**REVISIONS TO THE SCDOT SEISMIC DESIGN SPECIFICATIONS FOR**  
**HIGHWAY BRIDGES**  
**April 2020**

The revisions included herein shall apply to the SCDOT Seismic Design Specification for Highway Bridges and Bridge Design Memorandum DM0115.

**SHEAR KEY DETAIL**

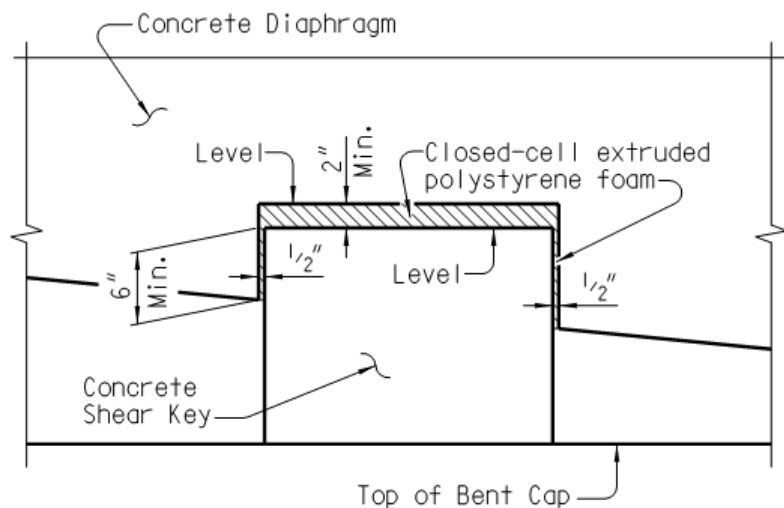
**Page 8, 9.2.2 Concrete Superstructure Shear Key Design:**

First paragraph is replaced with: “Shear keys shall be provided at bents with expansion joints, except as noted for SDC A bridges.”

Design shear keys that comply with the following detail:
